Como & Snelling

Station concept

Additional analysis based on draft plan input

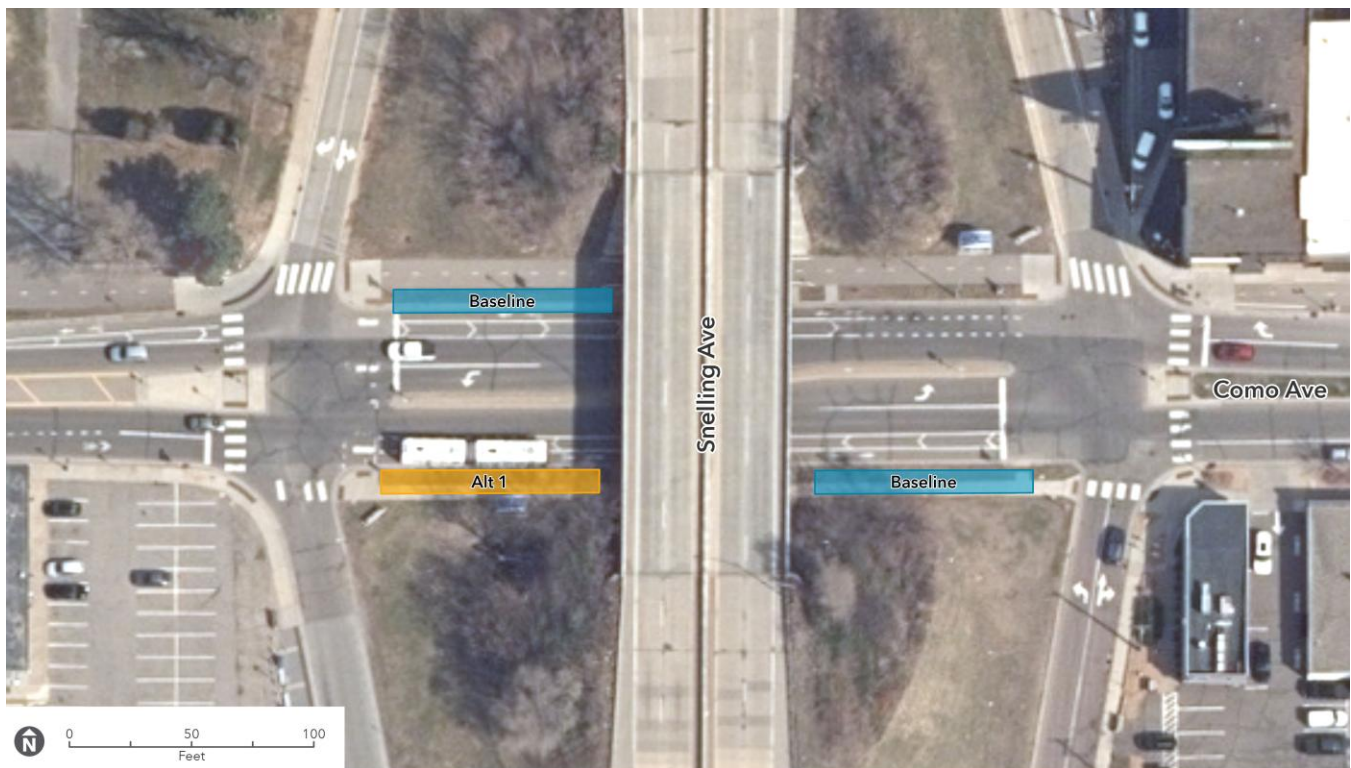
Public feedback received on the Draft Corridor Plan cited concerns about Como & Snelling Station eastbound platform placement and operational concerns related to transfers between the H Line and proposed Route 66 and A Line. Moving the eastbound platform to the Alternative 1 location will allow for a shorter transfer distance between eastbound H Line and southbound proposed Route 66. It is assumed that westbound H Line and northbound and southbound proposed Route 66 will both stop at the baseline westbound H Line station platform.

The priority with the Alternative 1 change is to accommodate proposed Route 66 transfers. Given the 30-minute headway, a missed transfer with proposed Route 66 results in up to 30-minute wait, while a missed transfer with A Line results in up to a 15-minute wait.

An alternative moving the Como Ave & Snelling Ave Station was evaluated:

- Baseline Alternative: Como & Snelling Station
- Alternative 1: Move Como & Snelling Station eastbound platform

Following review, Metro Transit project staff recommend moving the Como & Snelling Station eastbound platform to be farside of the southbound Snelling Avenue on/ off ramps west of Snelling Avenue. This change prioritizes transfers to the proposed Route 66 while still accommodating transfers between H Line and A Line. The on-street bike lanes on Como Avenue currently begin and end at the northbound on/ off ramps on the east side of Snelling Avenue. The beginning and end of the on-street bike lanes will be revised to the southbound on/ off ramps on the west side of Snelling Avenue. The corner curb extension on the southside of the roadway will accommodate a bike facility transition for people biking eastbound on-street to cross Como Avenue to access the two-way separated bike lane on the north side of the roadway.
